DRAWN	FOR SIGNATURES SEE REV. DATED: 15 SEP 86	<b>SEAL, EXTRUSION</b>	<b>CVR 144</b>
CHECKED			
STRESSED			SHEET: 1 OF 1
APPROVED

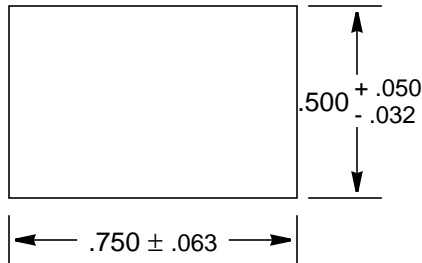
**(D)** NOTE 2a. DELETED

- NOTES:**
- ENGINEERING APPROVAL REQUIRED PRIOR TO EACH VENDORS FIRST PRODUCTION RUN
  - THE FLAMMABILITY REQUIREMENT SHALL BE AS FOLLOWS:
    - (D)** ~~a. F.A.R. 25.853 (b-2) AMEND 25-51~~
    - b. CVR144-1 THE REQUIREMENT IS OF F.A.R. 25.853 (b-2) AMEND 25-51 and 45° BURN THROUGH TEST ONLY OF F.A.R. 25.855 (a-1) AMEND 25-51
  - MINIMUM LENGTH 60"
  - ALL TOLERANCES PER RMA'S (THE RUBBER MANUFACTURERS ASSOCIATIONS INC.) RUBBER HANDBOOK.
